Central Valley Regional Water Quality Control Board

ORDER AMENDING CLEAN WATER ACT SECTION 401 TECHNICALLY CONDITIONED WATER QUALITY CERTIFICATION; CALIFORNIA DEPARTMENT OF TRANSPORTATION, 10-0G830 MERCED SEISMIC RESTORATION PROJECT (WDID#5B24CR00095A1), MERCED COUNTY

Amendment A1.1

Figure 9: Water Diversion Plan Stage 2, Los Banos Creek

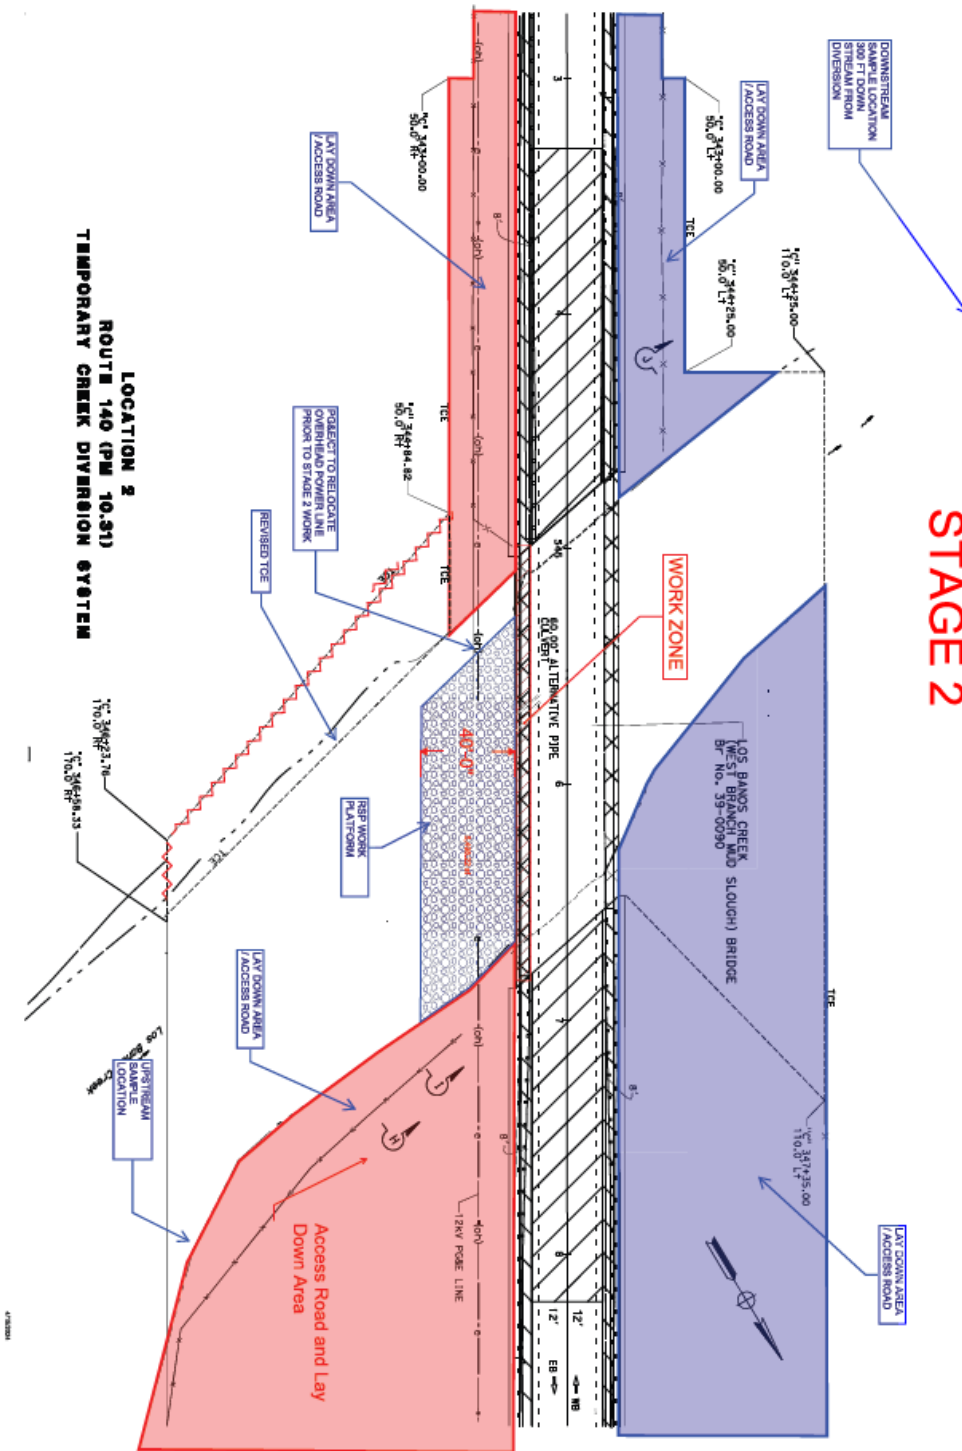
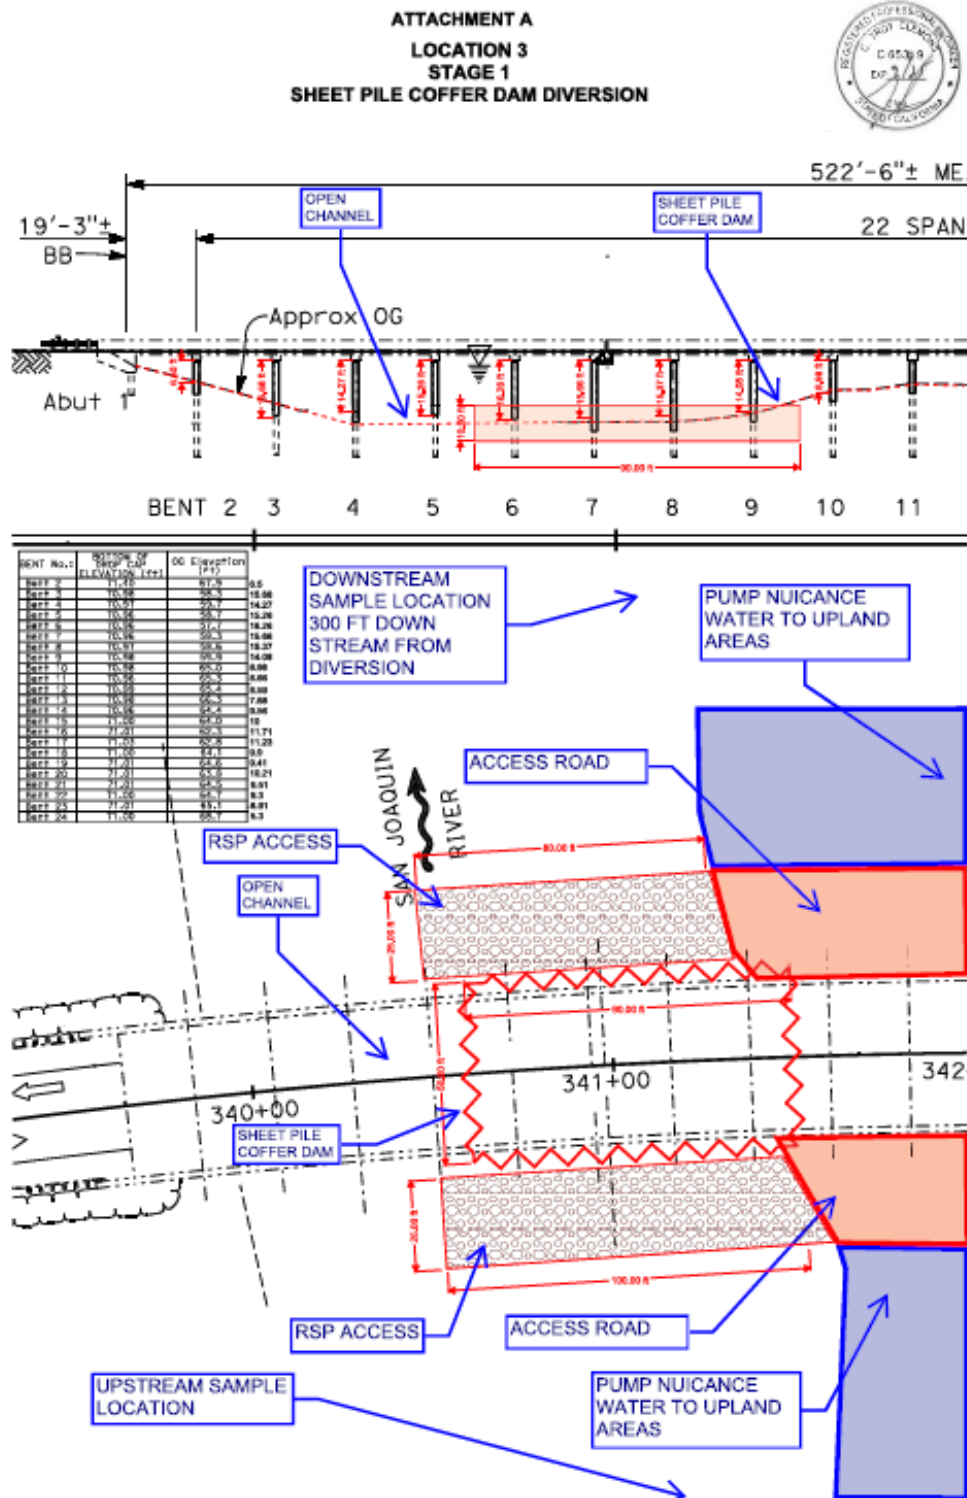
Caltrans is requesting a modification to the in-water work plans at Los Banos Creek and the San Joaquin River outlined in the original Certification's Project description. The modified in-water work plans result in reduced temporary dredge/fill impacts.

- The diversion at the Bear Creek Bridge will consist of gravel bag berm with an impervious membrane. Approximately 0.54 acre of channel will be dewatered on the north side and south side of the bridge. Flow will be allowed to continue through the center of the channel.
- At the Los Banos Creek Bridge, rock slope protection (RSP) will be placed in the channel on one side of the bridge to build a work pad up and out into the channel from the bank along with placing K-rail or rock-filled super-sacks to support the end of the work pad. The end of the work pad will stop short of the opposing bank by approximately 10 to 20 feet to allow for fish passage. Once work is complete on one side of the bridge, the RSP work pad will be removed and redeployed in the same fashion on the other side of the bridge.

Coffer dams (constructed from rock-filled super sacks or k-rail) will be constructed around every new set of pier piles where pile driving will occur in water. These coffer dams will isolate elevated turbidity from flowing water in the open channel and will not be dewatered. When heavy equipment is in use within the Ordinary High-Water Mark (OHWM) of Los Banos Creek, an absorbent boom will be placed downstream.

Approximately 0.35 acres of channel will be temporarily impacted from RSP installation, foot traffic, heavy equipment use, and any vegetation clearing. After the bridge pile work is complete, all coffer dams and RSP work pads will be removed and riverbed restoration will begin.

Figures 8-11 on pages 4-7 of this amendment are incorporated in Attachment A of the Certification.

Figure 10: Water Diversion Plan Stage 1, San Joaquin River

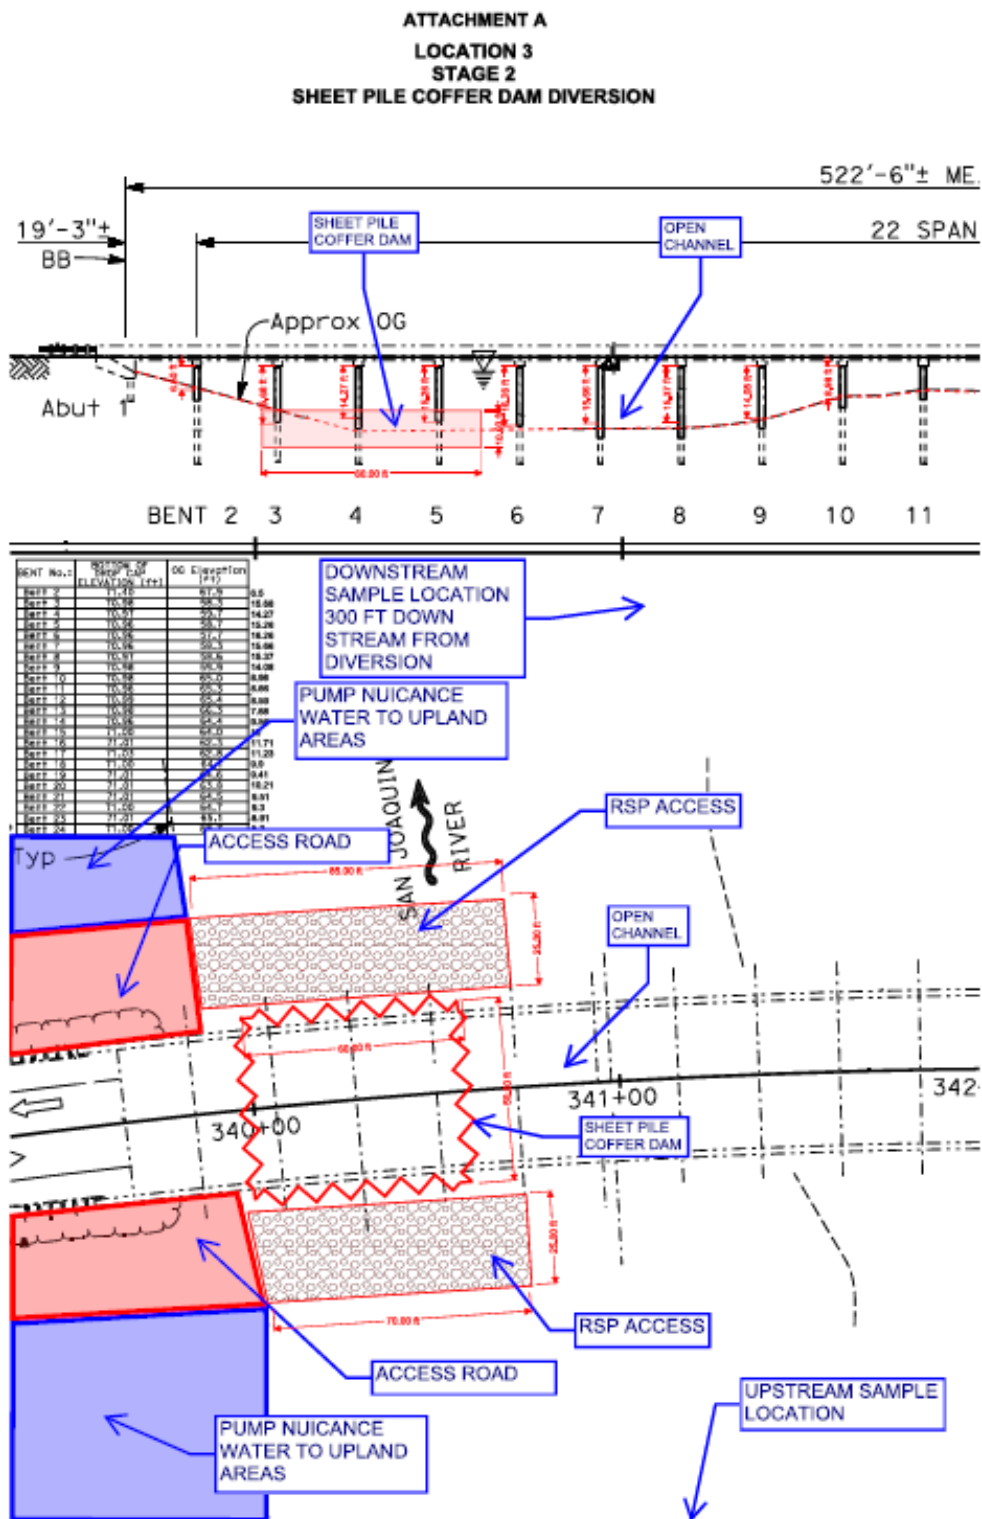
- At the San Joaquin River Bridge, a two-stage sheet pile coffer dam system will be installed around the bridge columns to be retrofitted. Water within the sheet pile coffer dams will be pumped to upland areas or other column excavations. RSP will be placed in the channel on both sides of the bridge to build a work pad up and out into the channel from the bank along with placing K-rail to support the end of the work pad. The end of the work pad will stop short of the opposing bank by approximately 30 to 50 feet to allow for fish passage. Once the first stage of the column retrofitting work is complete, the stage 1 coffer dam and RSP work pads will be removed and redeployed in the same fashion from the opposing bank so the stage 2 column retrofitting work can be done.

Approximately 0.37 acres of channel will be temporarily impacted as a result of RSP placement, foot traffic, heavy equipment use, and vegetation clearing. After stage 2 work is complete, the coffer dam and RSP work pads will be removed

and riverbed restoration will begin. When heavy equipment is in use within the Ordinary High-Water Mark (OHWM) of the San Joaquin River, an absorbent boom will be placed downstream.
